Company	Trenz Electronic GmbH
PCN Number	PCN-20190109
Title	TE0808-04-* SPI Flash Change
Subject	BOM change
Issue Date	2019-07-15

This change affects Trenz Electronic TE0808-04 SoMs: TE0808-04-*

Locate Flash (U7, U17) on bottom side of PCB:

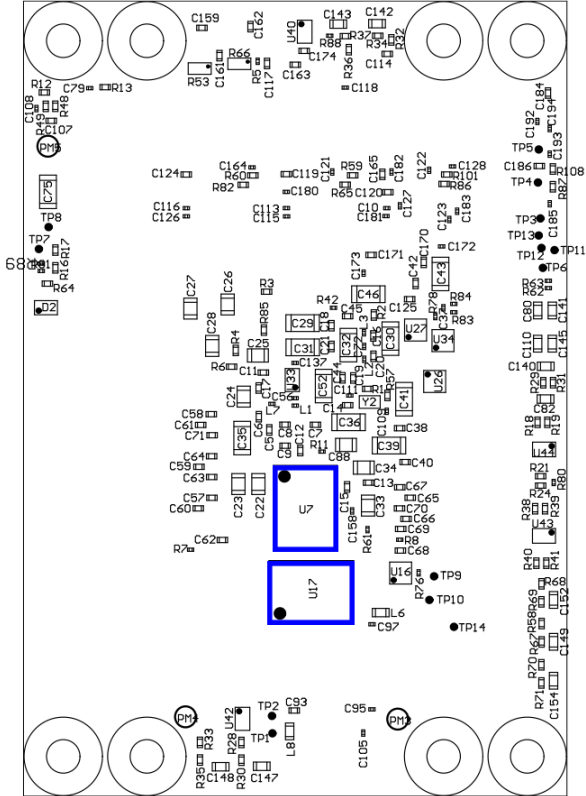
#1 Change SPI Flash from N25Q512A11G1240E to MT25QU512ABB8E12-0SIT

Reason: N25Q512A11G1240E became obsolete.

Impact: None. Both have same JEDEC ID BB20h and manufacturer ID 20h.

old	new
N25Q512A11G1240E	MT25QU512ABB8E12-0SIT
